UNITED STATES PATENT AND TRADEMARK OFFICE

APPLICATION NO.	FILING DATE	FIRST NAMED INVENTOR	ATTORNEY DOCKET NO.	CONFIRMATION NO.
10/824,116	04/13/2004	Tomonari Itou	FP04-017US	6449
1218	7590	02/23/2005	EXAMINER HARVEY, JAMES R	
CASELLA & HESPOS 274 MADISON AVENUE NEW YORK, NY 10016			ART UNIT 2833	PAPER NUMBER

Office Action Summary

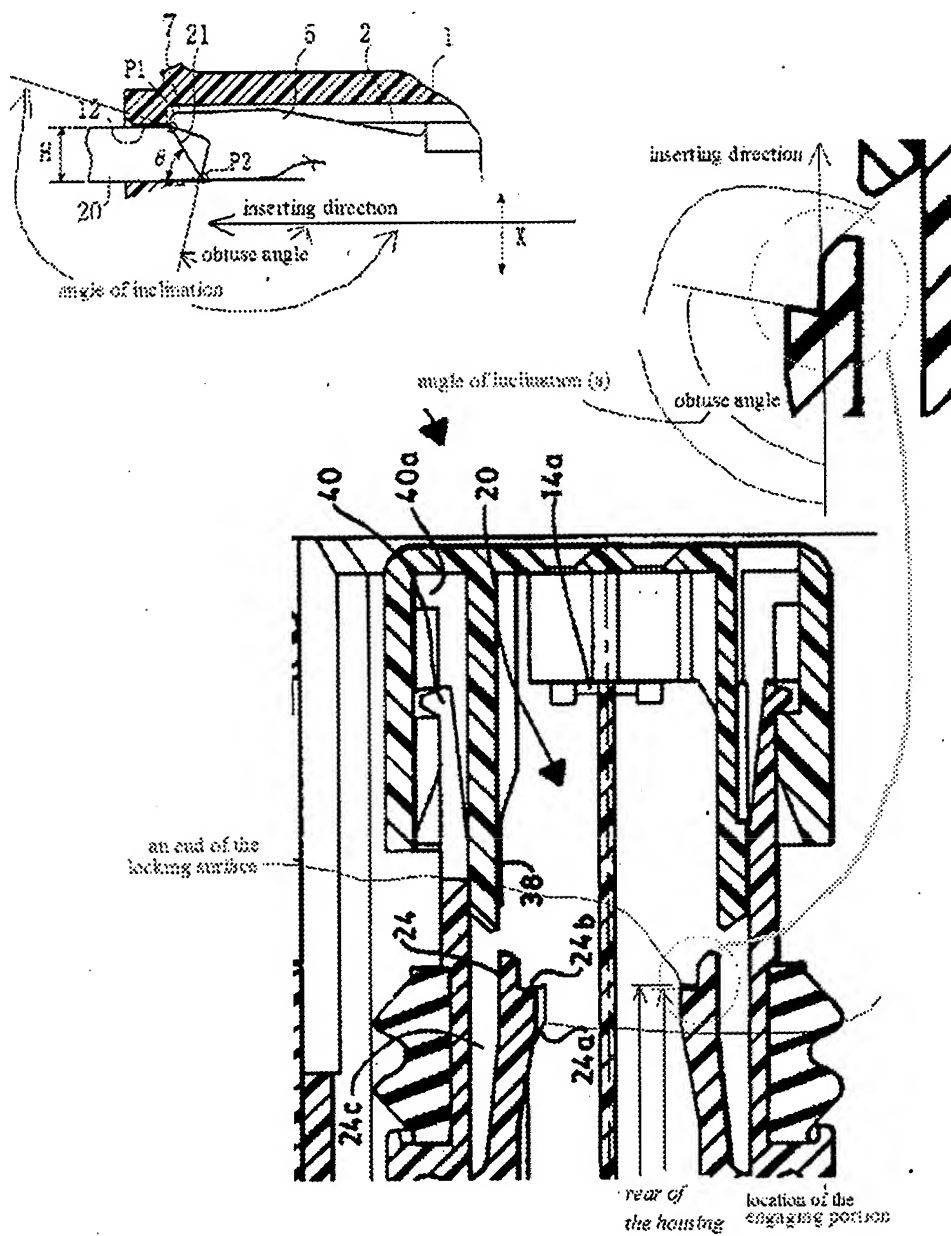
the locking surface 24b of the lock 24 being slanted to form an obtuse angle (a) with respect to the inserting direction (see examiner's figure).

the locking surface (near the lead line of numeral P2 (figures 3C)) of the lock 5 being slanted to form an obtuse angle (see examiner's figure) with respect to the inserting direction.
